**HORIZONTAL DIRECTIONAL DRILL ANALYSIS
LEWISBERRY ROAD CROSSING
PADEP SECTION 105 PERMIT NO.: E67-920
PA-YO-0016.0000-RD-16
(SPLP HDD No. S2-0260-16)**

**LEWISBERRY ROAD CROSSING
PADEP SECTION 105 PERMIT NO. E67-920
PA-YO-0016.0000-RD-16
(SPLP HDD No. S2-0260-16)**

REVISED HORIZONTAL DIRECTIONAL DRILL DESIGN SUMMARY: 16-INCH

Figure 2. Redesigned 16-Inch HDD Plan and Profile

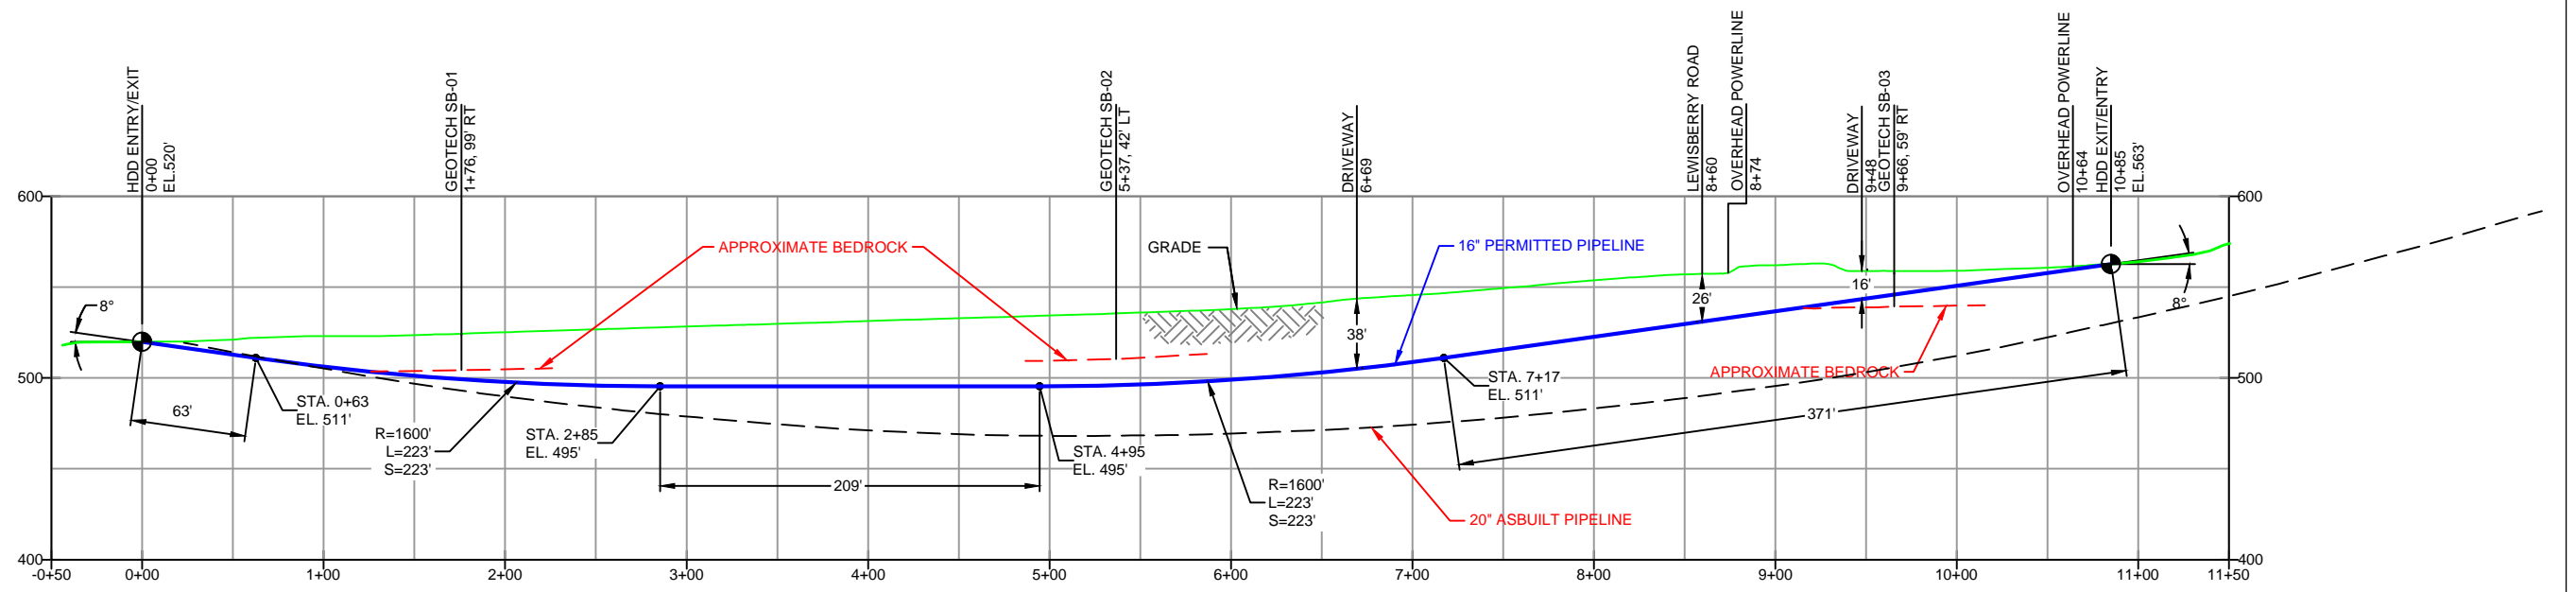
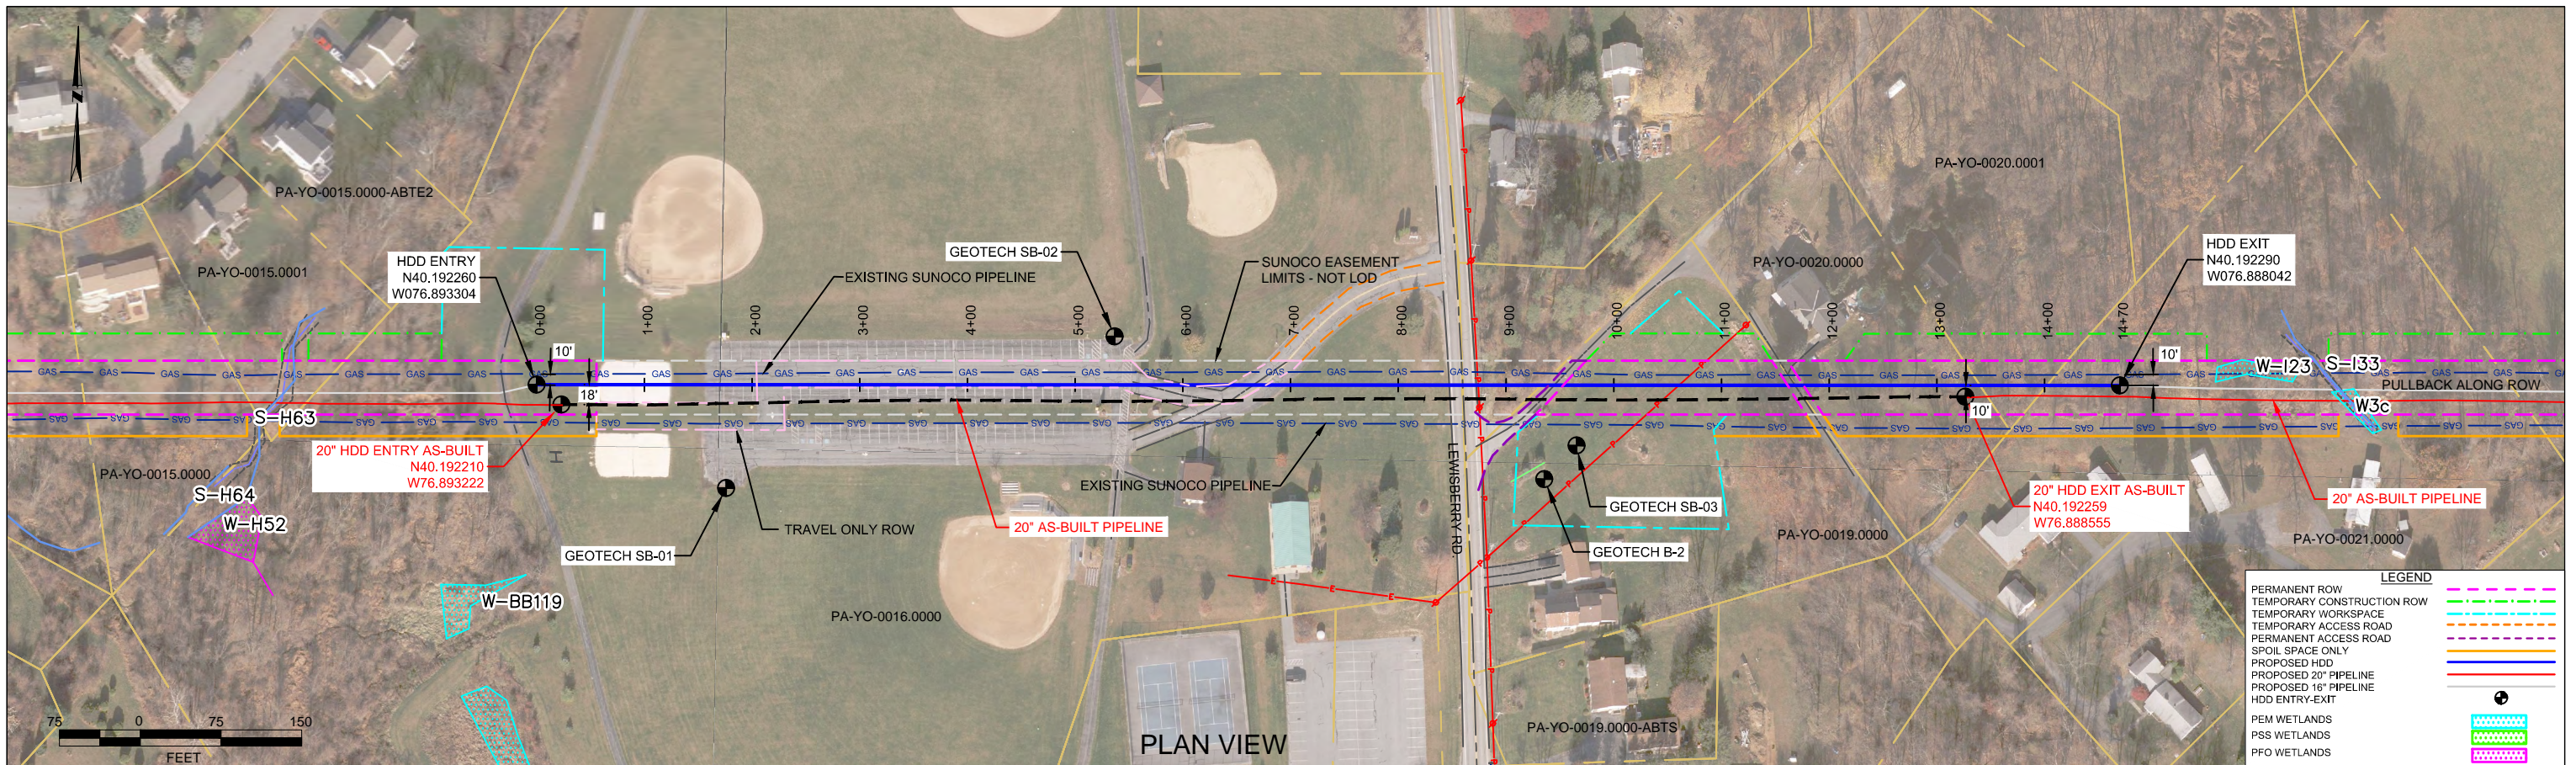
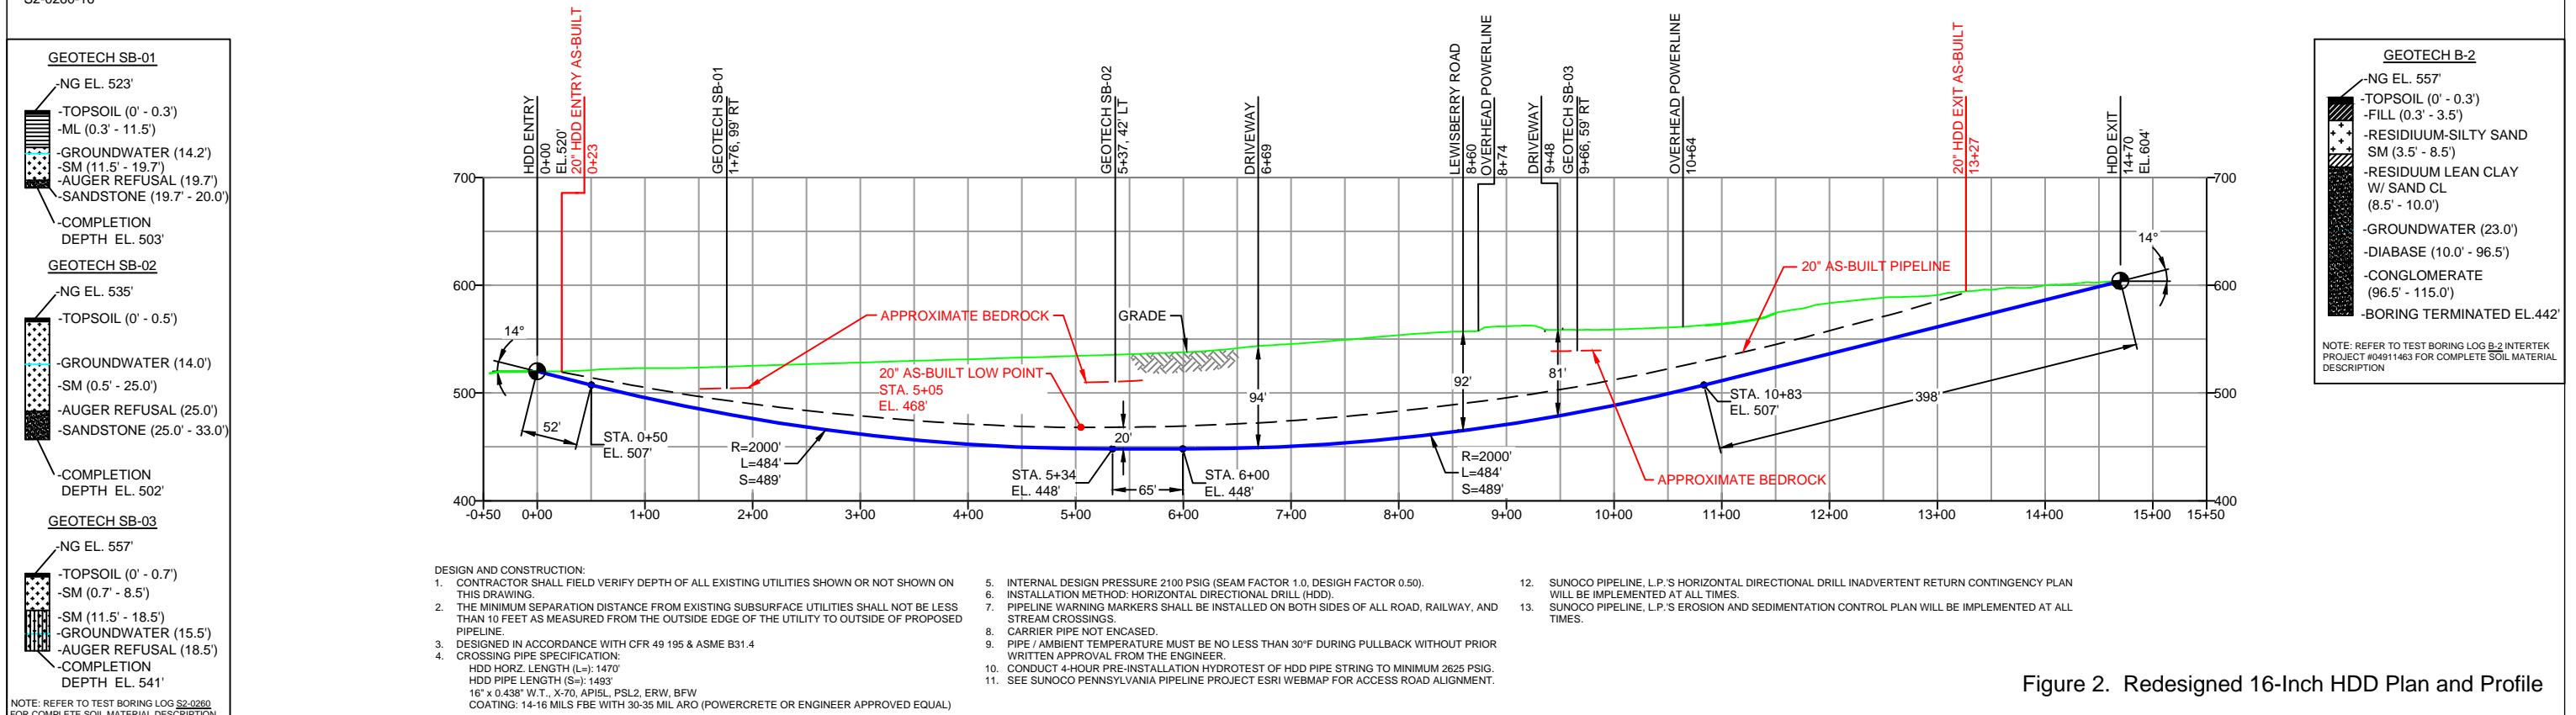
An additional geologic investigation has been completed, and the "as built" record for the 20-inch pipeline has been utilized in the redesign of the planned 16-inch HDD. The redesign adjusts the HDD profile deeper to minimize the risk of drilling fluid loss, drilling difficulties, and IRs. A summary of the redesign factors is provided below. The permitted and redesigned 16-inch HDD plan and profile drawings are provided in Attachment 2. A summary of the redesign factors is provided below.

As shown on Figure 2, the redesigned HDD profile for the 16-inch pipeline is 385 ft longer, with a maximum depth of cover increased by approximately 56 ft from the permitted design, and increased entry and exit angles to decrease drilling time between exiting bedrock and the land surface.

- Horizontal length: 1,470 ft
- Entry/Exit angle: 14 degrees
- Maximum Depth of cover: 94 ft
- Pipe design radius: 2,000 ft
